City of West Linn
PRE-APPLICATION CONFERENCE MEETING
July 17, 2014

SUBJECT: 4-lot Subdivision and Class II Variance at the southeast corner of Salamo Road and Hoodview Avenue.

FILE: PA-14-30

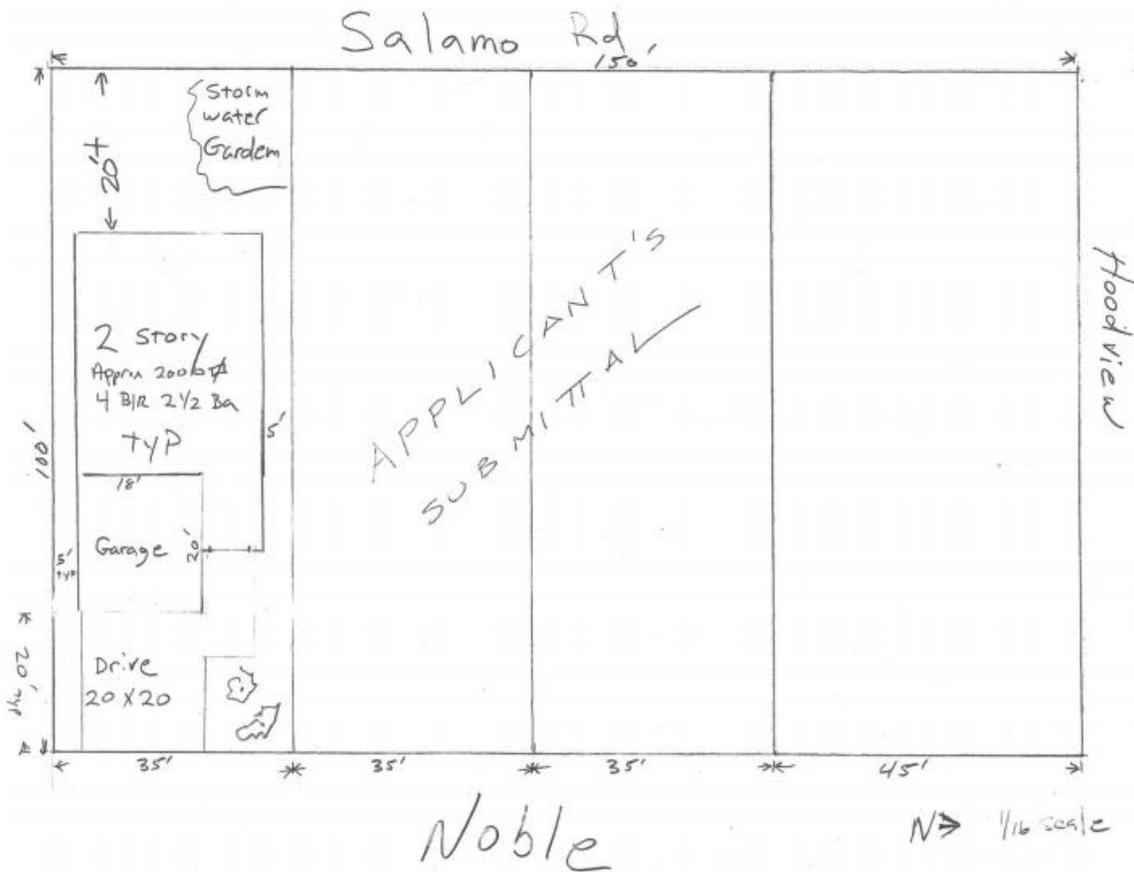
The site topography has a modest 6.8 percent slope (from 694 at the south to 684 foot elevation at the north). There are no trees at the site or significant groundcover. No tree inventory will be required. There are no natural hazards or environmental constraints (wetlands etc.) on this property.

All lots within this proposed subdivision will have to meet the size and dimensional standards of the R-3 zone. The applicant proposes four lots. Three lots would comprise 3,500 square feet (35' W X 100' L) and the lot at the corner would comprise 4,500 square feet (45' X 100' L). The R-3 minimum lot width of 35 feet is met. The minimum lot depth of 75 feet is also met.

Staff discussed the possibility of two shared driveways for this application. The driveways would be a minimum 20 feet wide with three foot wings on each side for a total width of 26 feet. Even by sharing driveways, the width between them would be 44 feet, which is six feet shy of the standard.
